Board of County Commissioners - Staff Report

Meeting Date: September 15, 2026 **Submitting Dept:** Planning & Building Services
Presenter: Chandler Windom **Agent:** Amberley Baker
Property Owner: JHHR Holdings I, LLC
Subject: DEV2026-0002 Northern South Park Area I Development Plan

A Development Plan pursuant to Sections 8.3.2 and 4.5.1 of the Land Development Regulations (LDRs) for a Master Site Plan in Area 1 of the Northern South Park Incentive Overlay.

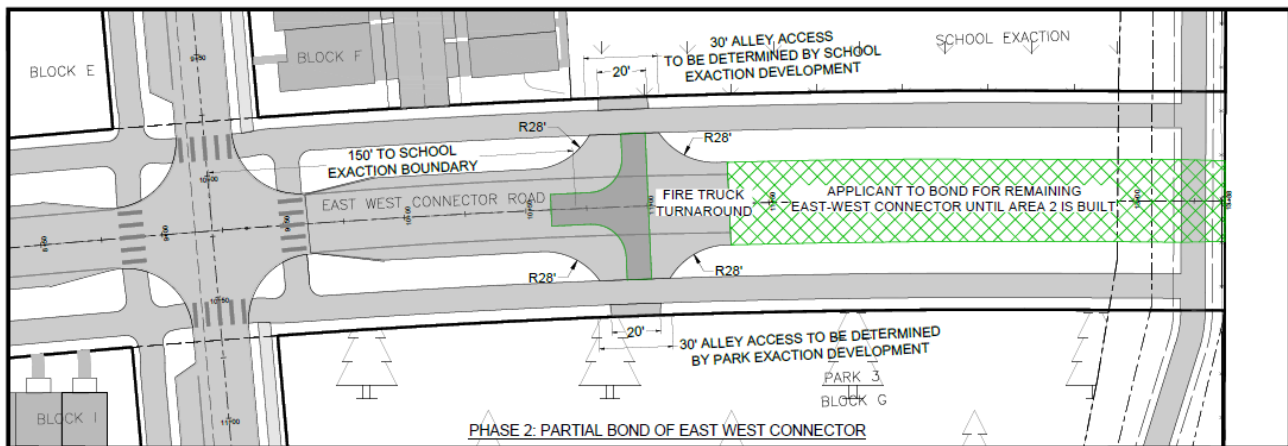
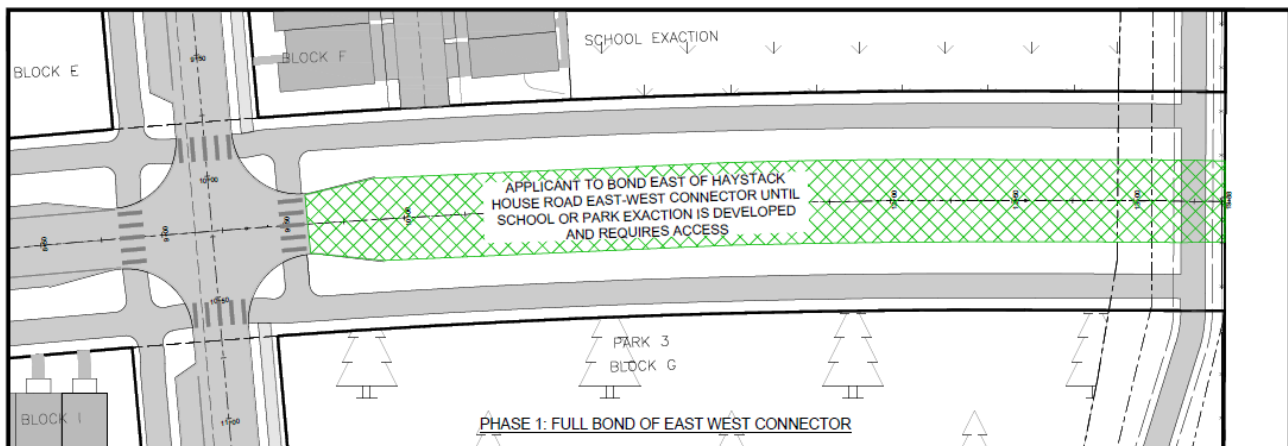
The East-West Connector roadway terminates at the boundary between NSP Area 1 and Area 2, and this last segment is over 350 feet, which does not comply with NSP road standards for cul-de-sacs. It was determined through the Master Site Plan process that the applicant could only be responsible for providing their portion of the "Connector" that was on their private property. The applicant has proposed three alternatives for the terminus of the East-West Connector Road (copied below) and requested flexibility from the County Engineer on this standard.

The County Engineer does not support the intentional construction of a dead-end roadway as part of NSP Area 1. The Master Site Plan (excerpt highlighted below) labeled the access connection between the Area 1 terminus of the East-West Connector Road and Road 6 in Block Q as "this segment may be a road or a pathway." The applicant states that this was for the benefit of Block G, which now contains Park 4 and no housing.

if desired by the applicant. If the continuation of the East-West Connector through Area 2 comes to fruition, then the roadway part of that segment could be removed and reverted to just a pathway. There is benefit to isolated and protected pathways, however providing this connection and redundancy creates a better road network for this neighborhood, should road connection further east not be provided.

SHEET TITLE:
RESPONSE TO STAFF PROPOSED
CONDITIONS 4.B

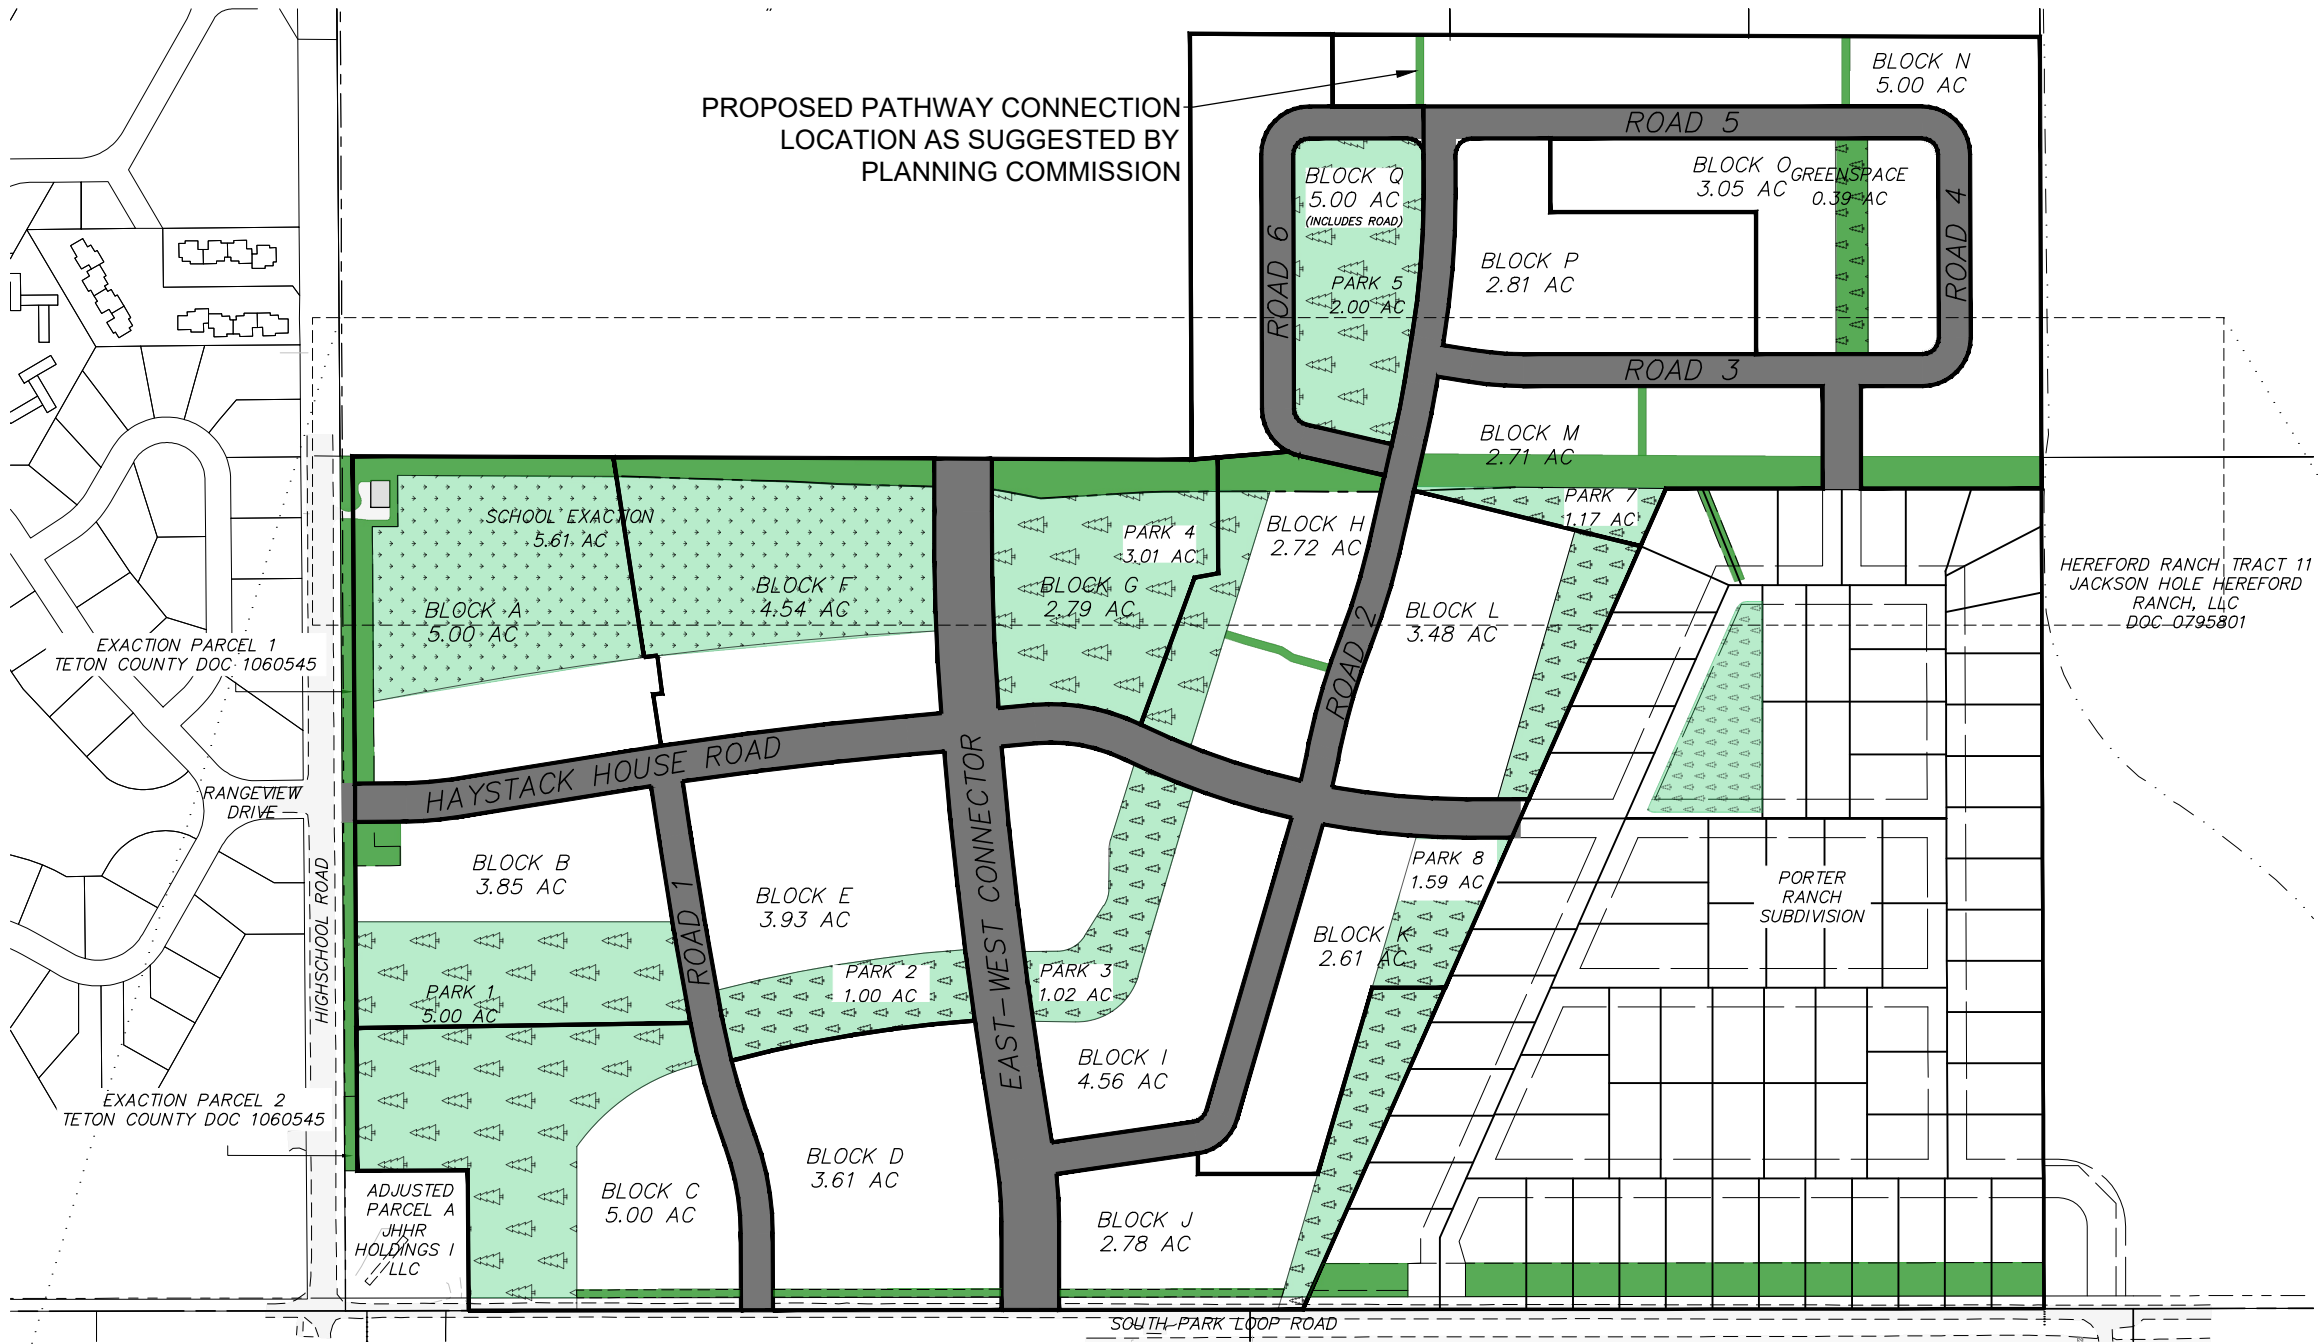
The applicant is opposed to this condition as reiterated in their September 4, 2026, memo, citing wildlife permeability, conflicts with utilities, and intersection separation concerns. The applicant instead offers a phased approach to bonding for the easternmost leg of the East-West Connector, described visually below, to avoid having a dead-end on a stretch of road longer than 150 feet. Bonding for critical infrastructure through a financial assurance has its own administrative challenges, especially with an unknown timeline for the rest of the roadway, but it is an option for the Board to consider.

Yellow = applicant proposal, Purple = suggested alignment

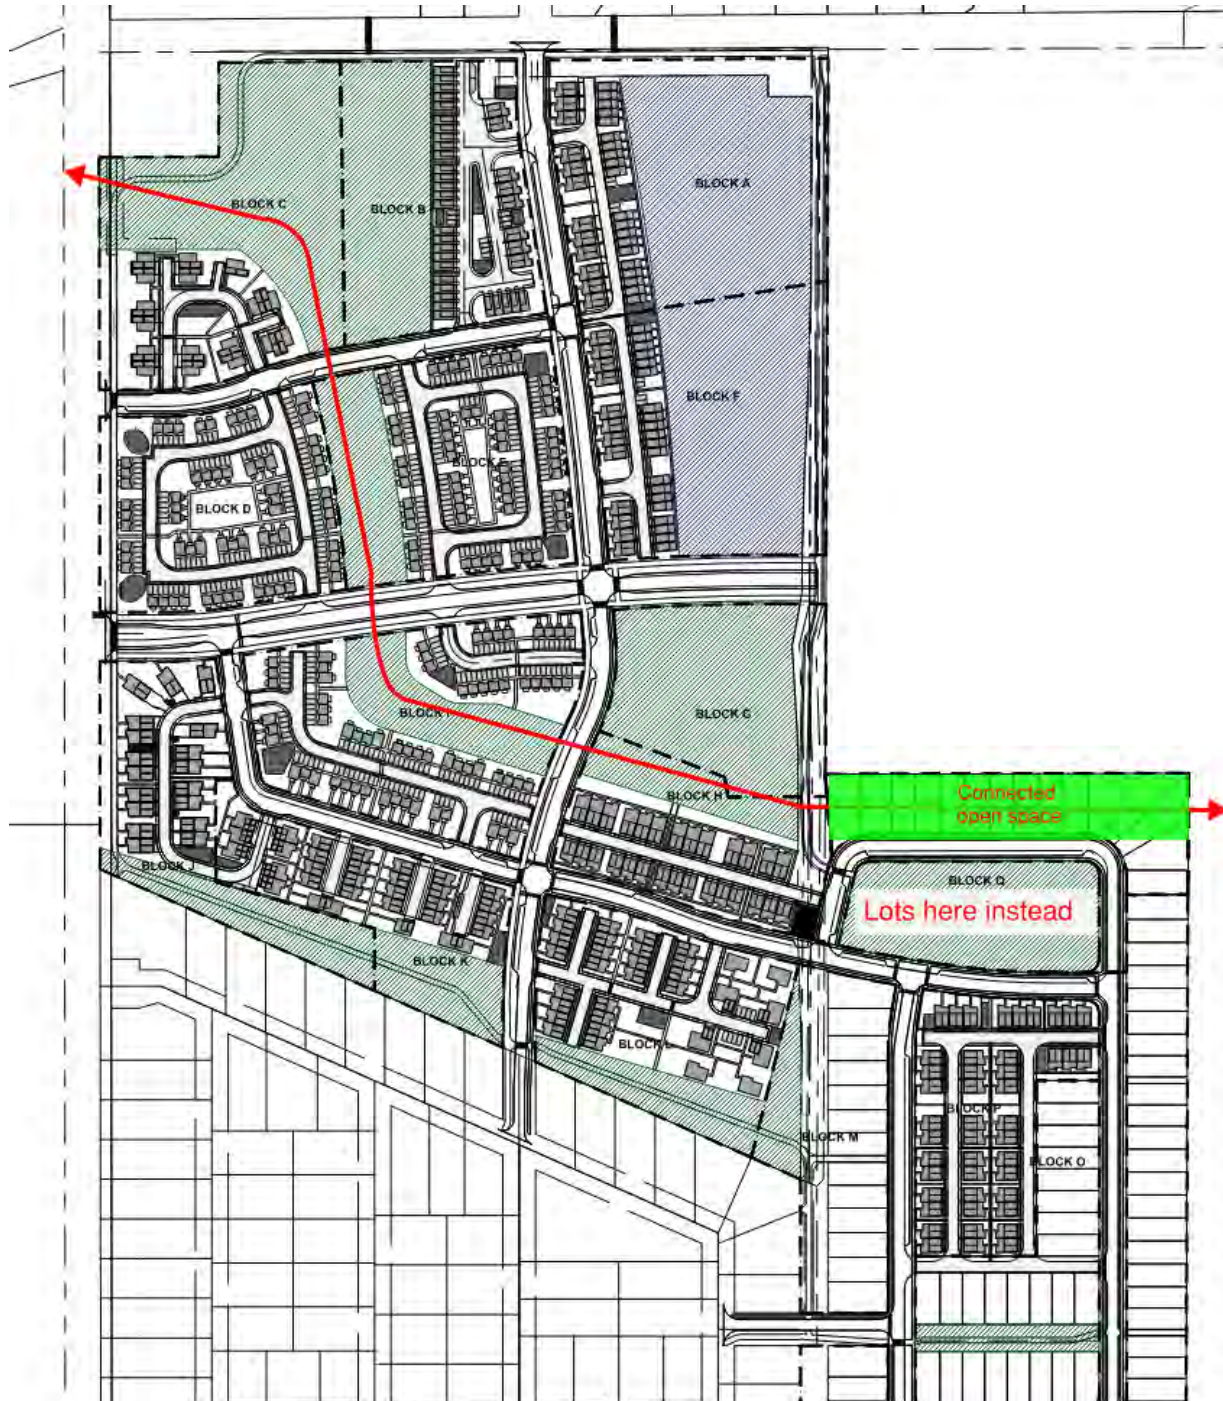
6. Block Q will function as a potential wildlife trap, similar to conditions observed in the Cottonwood subdivision, where wildlife may enter but lack clear exit pathways. Lots could instead be internalized within Block Q while maintaining an open east-west corridor along the northern edge to connect with open space in Blocks G and H. This would create a more continuous and functional movement corridor. See figures below:

7. As an alternative to reconfiguration suggested above, consider requiring a larger setback along the northern boundary of Block Q to function as a natural vegetation buffer. This could be similar in scale and intent to the 52-foot buffer required in the Porter Ranch Subdivision along South Park Loop Road.

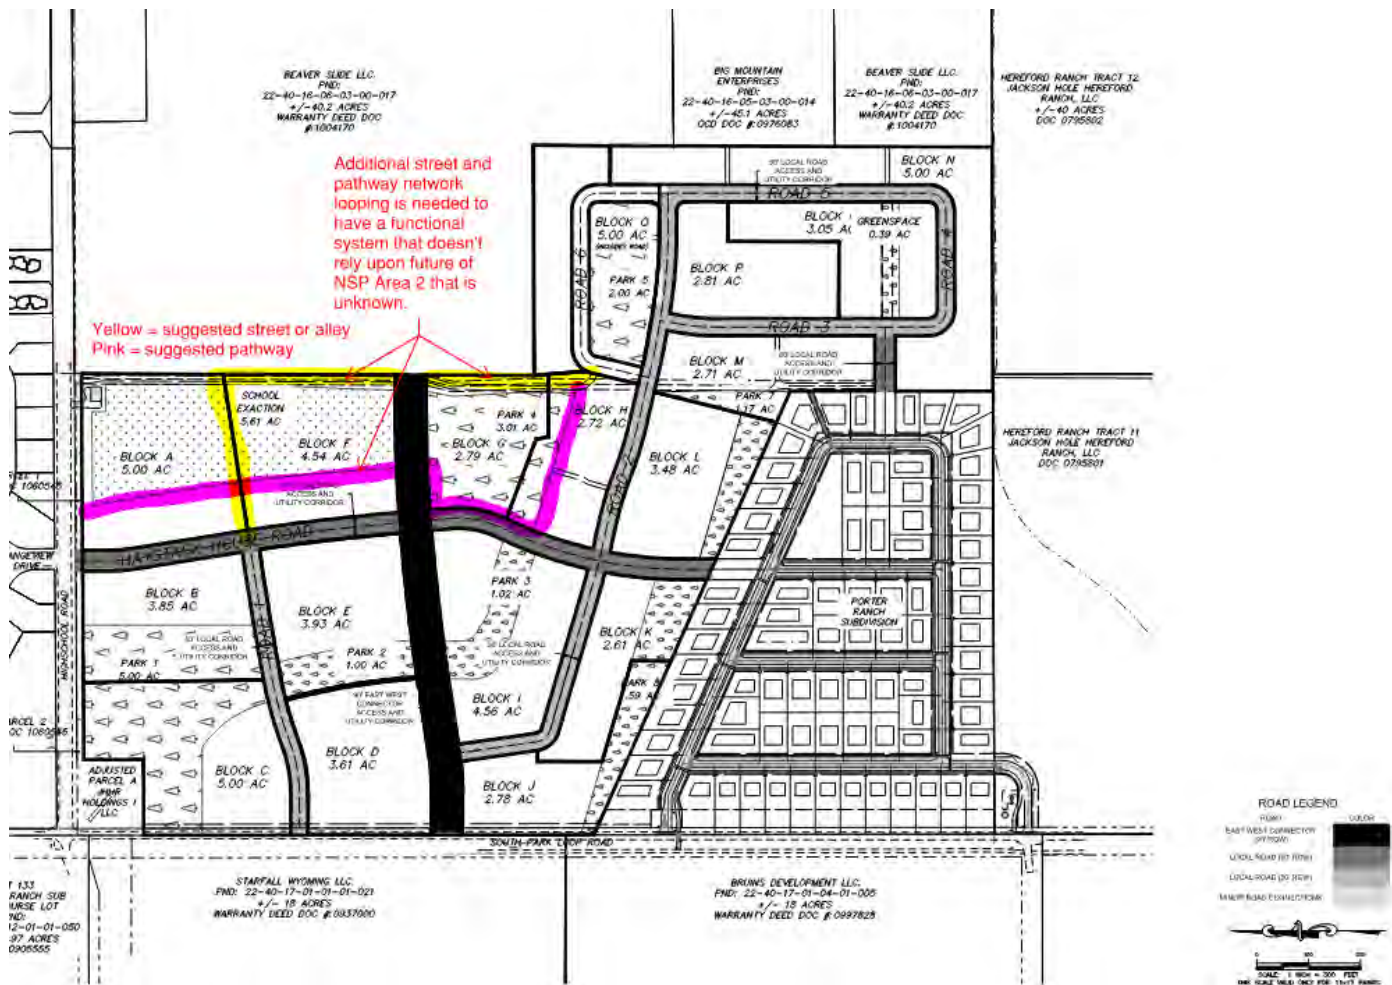
Furthermore, even if a turnaround meeting County standards were provided, **The County Engineer does not support the intentional construction of a dead-end roadway as part of NSP Area 1.** The proposed design relies on a future connection to Area 2 at an unspecified time, and there is no assurance that Area 2 will be developed within a foreseeable timeframe, if at all. The roadway should be designed to function independently as part of the NSP Area 1 development, not wait for some unknown future.

Creation of an E-W Connector Road has been contemplated for many years in this area, once development occurred, as discussed in the Jackson/Teton Integrated Transportation Plan (ITP). While the applicant has provided the easement necessary within Area 1, they have communicated that will not obtain easements from NSP Area 2 landowners to plan for and construct a functional network road connection for NSP Area 1. Therefore, **the County Engineer strongly recommends connecting the E-W Road to some other proposed surrounding streets to create a looped network. This may require rethinking the proposed street and pathway network layout** and even how roads and pathways are connected to High School Road and South Park Loop Road. Alternative configurations and creative solutions are encouraged, and an **illustrative suggested concept is provided in the figure below:**

Figure A. Improving Intersection Visibility¹

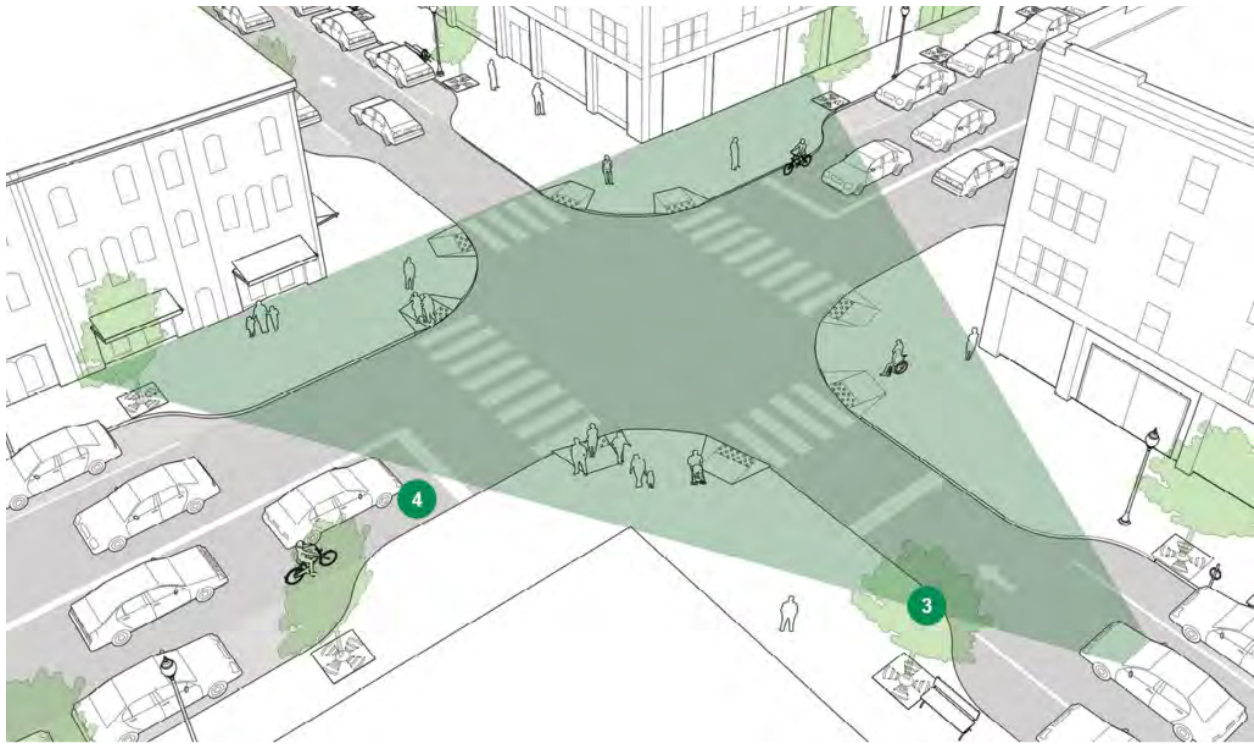
Wyoming state statute requires that no vehicles be parked within 20 feet of a crosswalk for intersection 'daylighting' to improve sight distances for pedestrians and vehicles at all legs of the intersection. NACTO guidance suggests 30 feet is a best practice. Staff recommend the daylighting area around each intersection meet the NACTO guidance of 30 feet.

Figure 1: Raised Pathway Crossing. Typical for all pathway/sidewalk crossings at "Alleys" and "Roads"

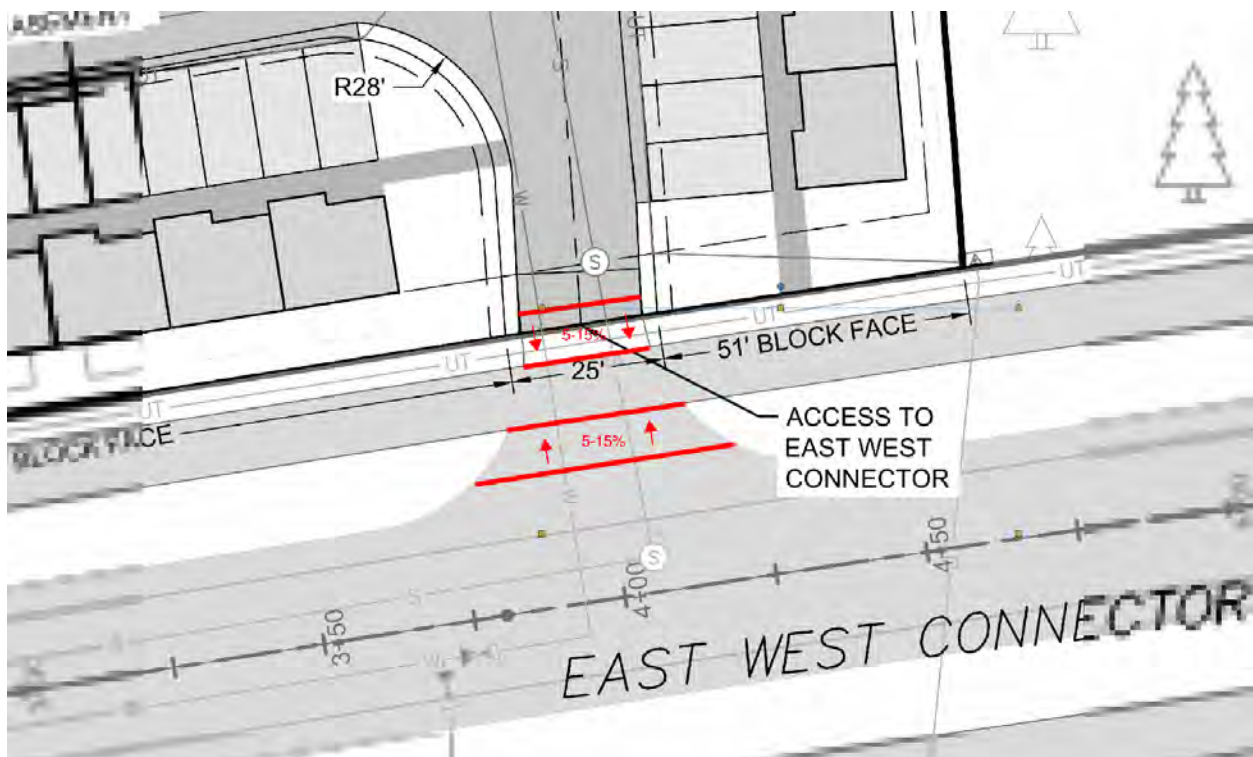
3. Elevated Crossings/Continuous Sidewalks and Pathways - See AASHTO 2024 Bike Guide Section 5.10.5

- b. At locations where pathways and sidewalks that parallel Haystack or the E-W Connector cross a “Road” and Haystack/E-W does not have a stop sign, the pathway/sidewalk should be elevated and continuous across the “Road”. An example of this is the intersection of Road 1 and Haystack on Sheet ROW C4.6.
- c. Pathway crossings at all midblock locations should have raised crossings. Examples of this are the midblock crossing between K and L on Sheet ROW C4.5 and the crossing of Road 5 on Sheet ROW C4.11.
